**ADDENDUM NO. 2 TO PROJECT NO. 45149**

**CONSTRUCTION WORK AND PLUMBING WORK  
PROVIDE STRUCTURAL REPAIRS TO PARKING GARAGE  
EMPIRE STATE PLAZA EAST PARKING GARAGE  
PHILIP STREET,  
ALBANY, NY**

June 2, 2017

**1** EXPANSION JOINT DETAIL  
A-508 3/4"=1'-0"

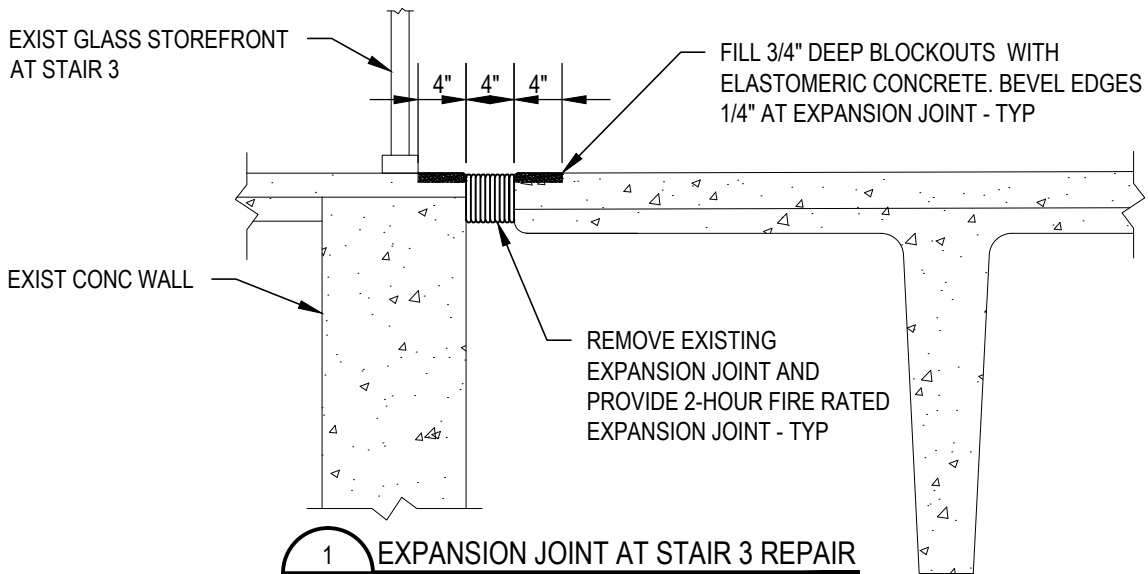
- 7. Drawing No. A-508, Detail 1: Delete this Detail in its entirety. See Addendum Drawing No. A-511 which accompanies this Addendum for replacement detail.

THIS DETAIL REPLACES DETAIL 1/A-508 ON SHEET A-508

**1** EXPANSION JOINT AT STAIR 3 REPAIR  
A-511 3/4"=1'-0"

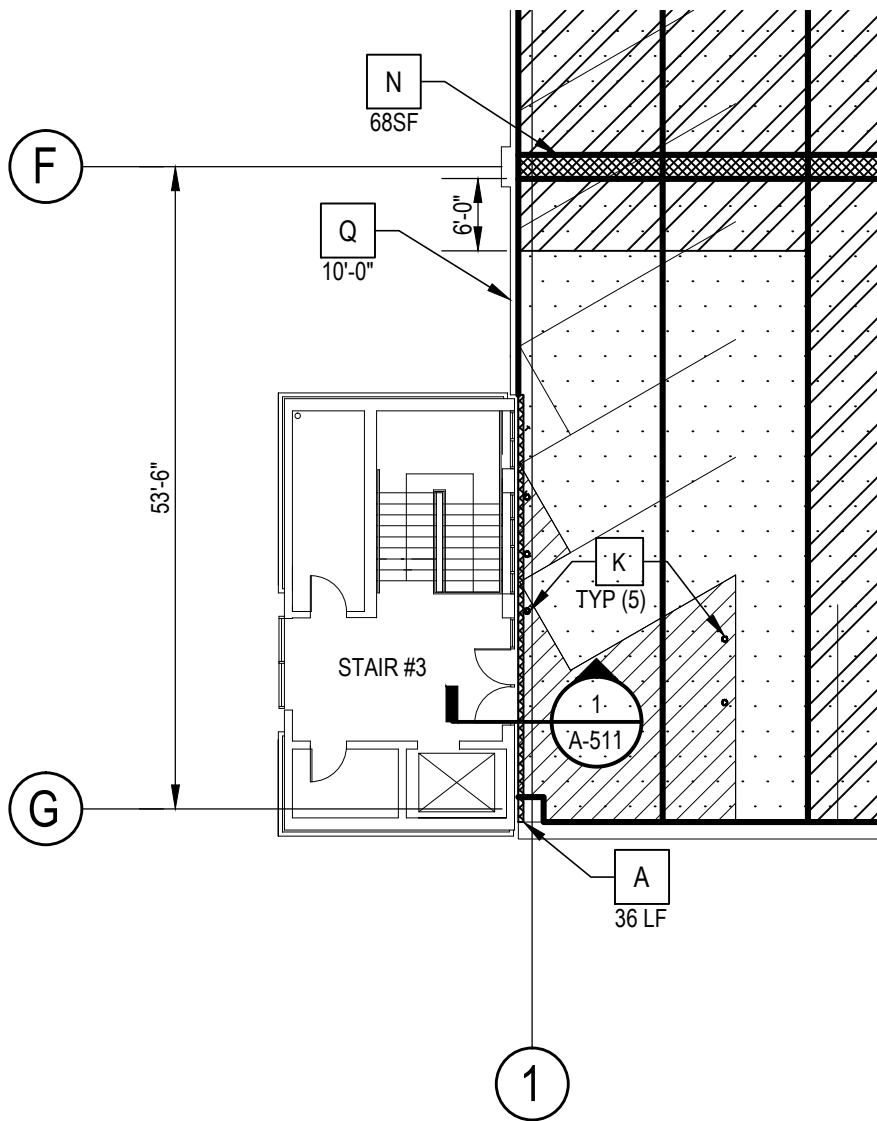
USE THIS DETAIL AT STAIR 3 INTERSECTION OF WALL AND DECK BETWEEN COLUMNS F AND G. REFER TO PLAN BLOW UP ON SHEET A-512.
